RFP Title: Amphitheater Stage Improvements at Waterplace Park

Addendum #: 1

AMPHITHEATER STAGE IMPROVEMENTS AT WATERPLACE PARK
Providence, Rhode Island
ADDENDUM No. 1

SHEET TITLE
ELECTRICAL SITE PLAN

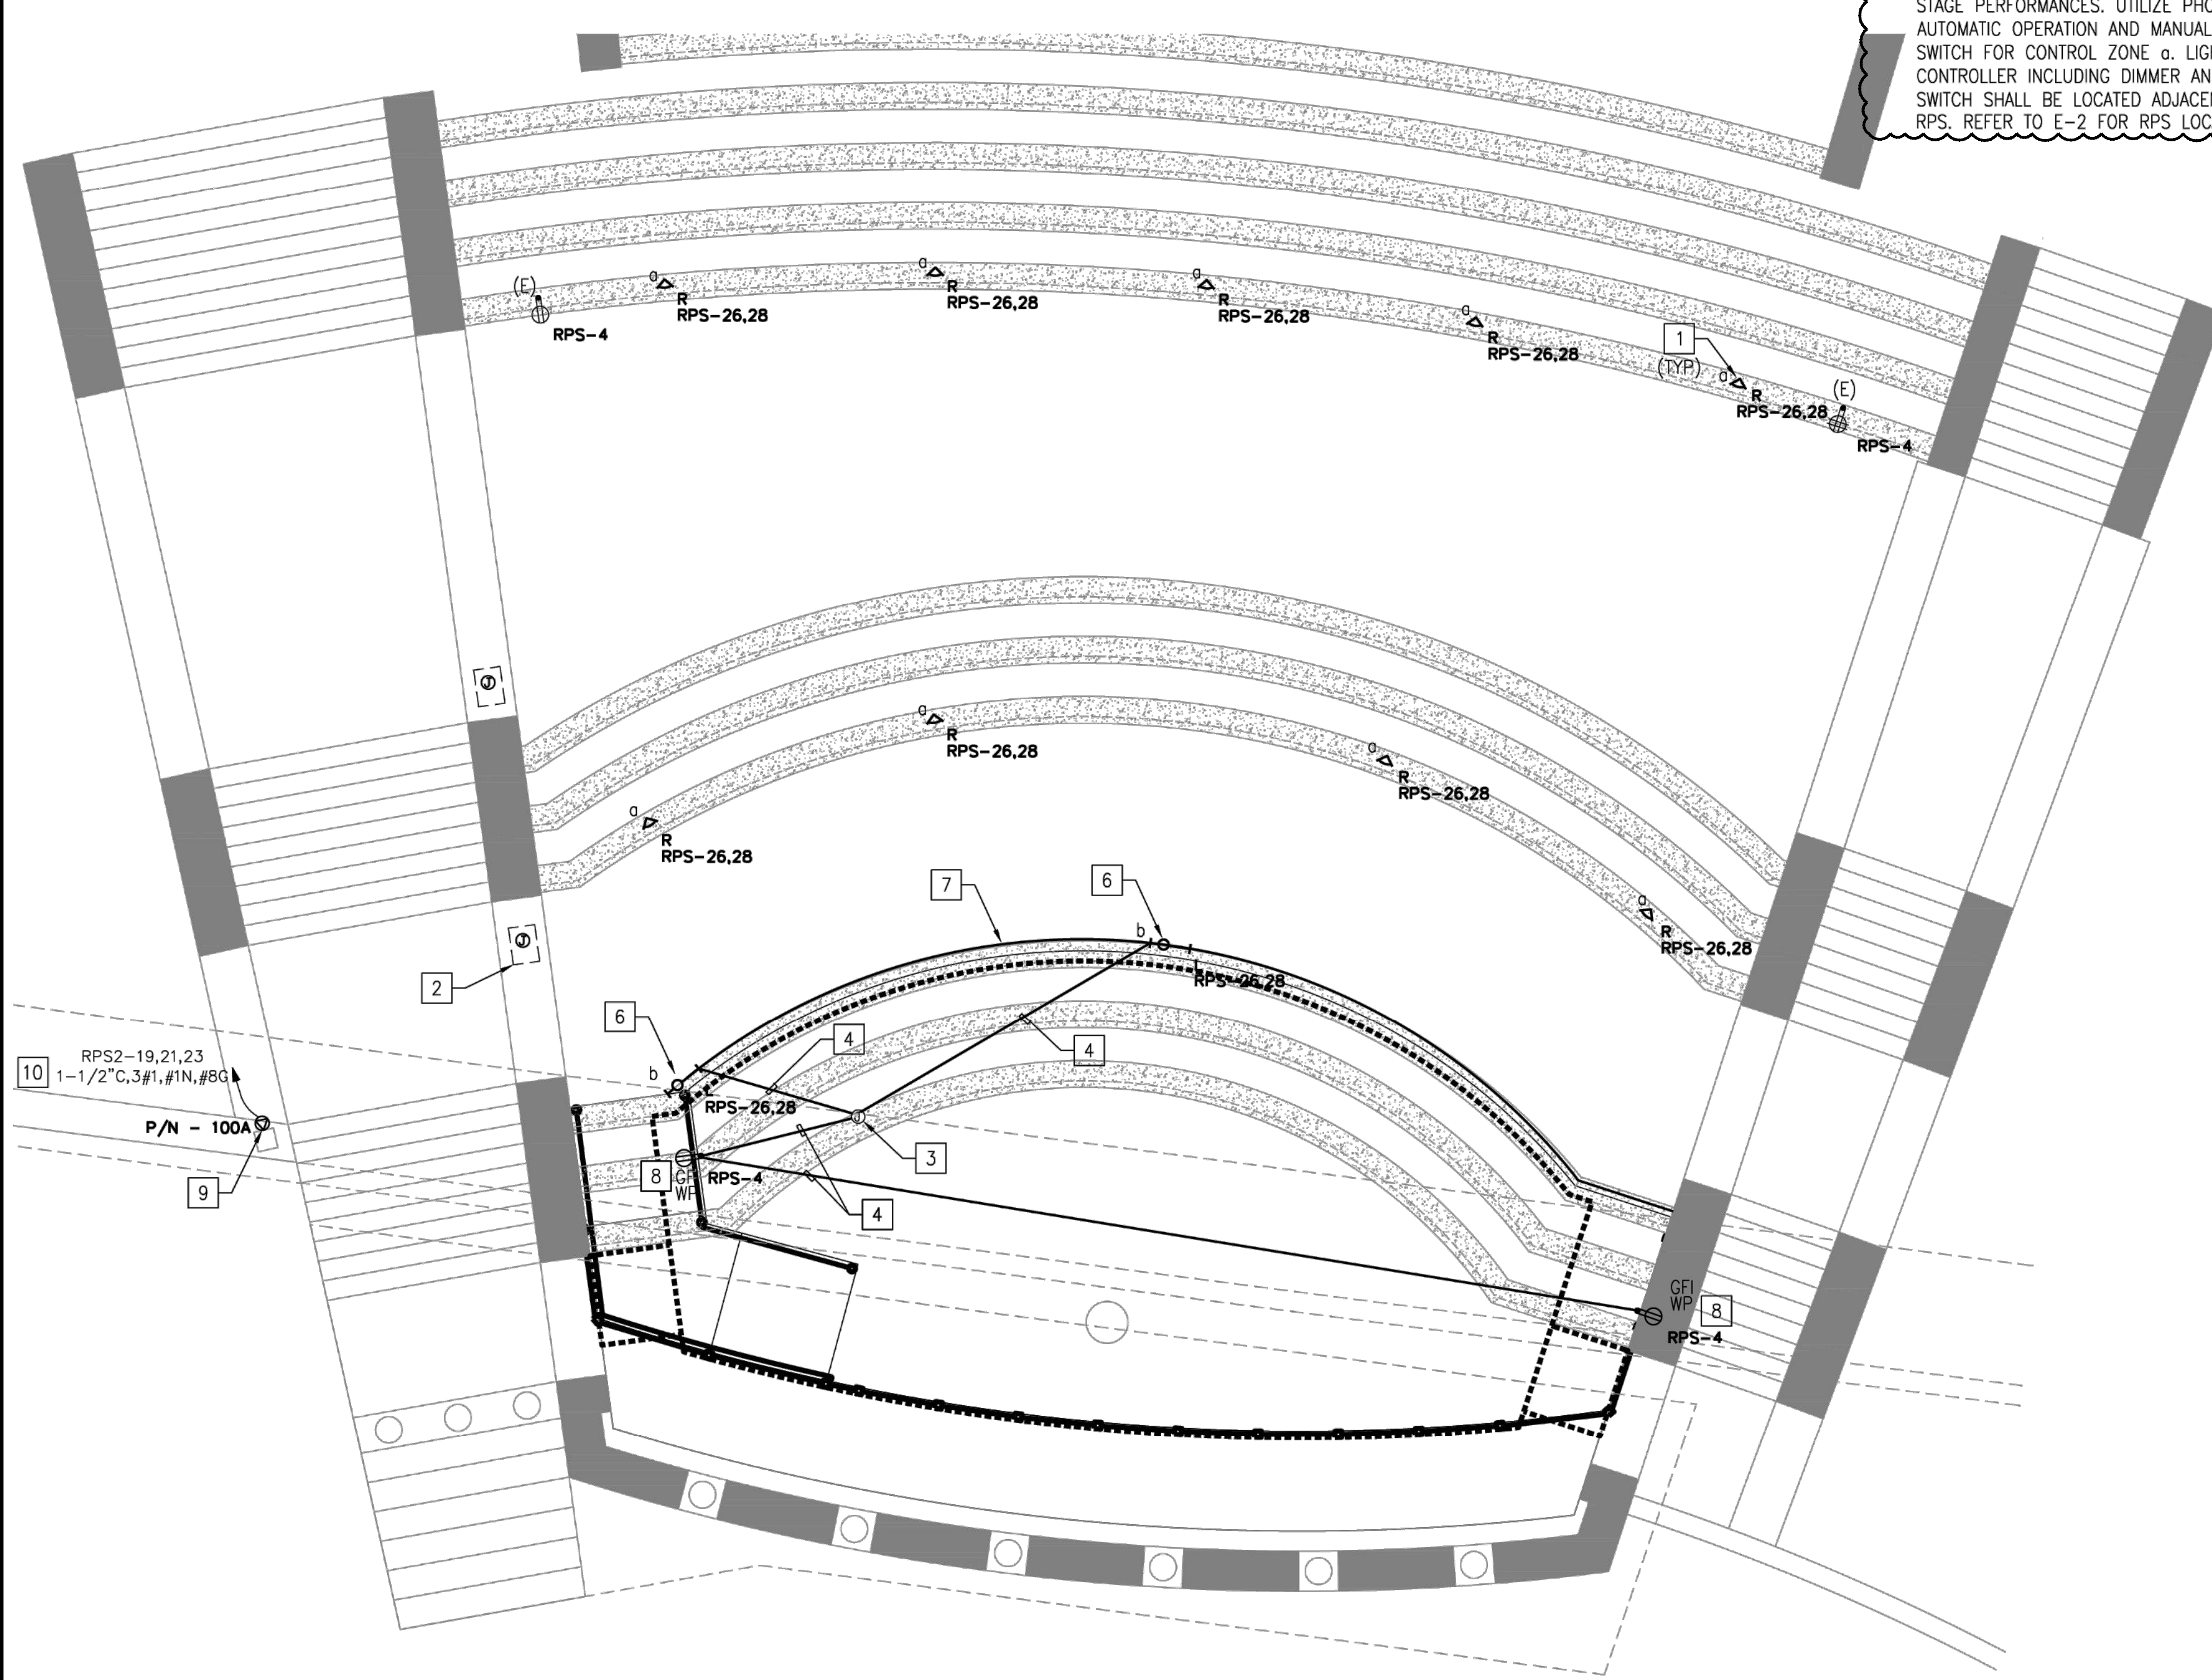
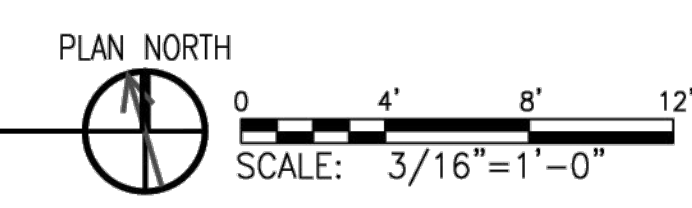
2. E-3 ELECTRICAL SITE PLAN

DELETE Sheet E-3 in its entirety.

INSERT Sheet E-3 (REV. 1). General Sheet Note No. 2 and Key Note No. 9 have been revised. Additionally, the dimming driver for the proposed surface mount step light ("0-10V" in the Luminaire Schedule) has been stricken.
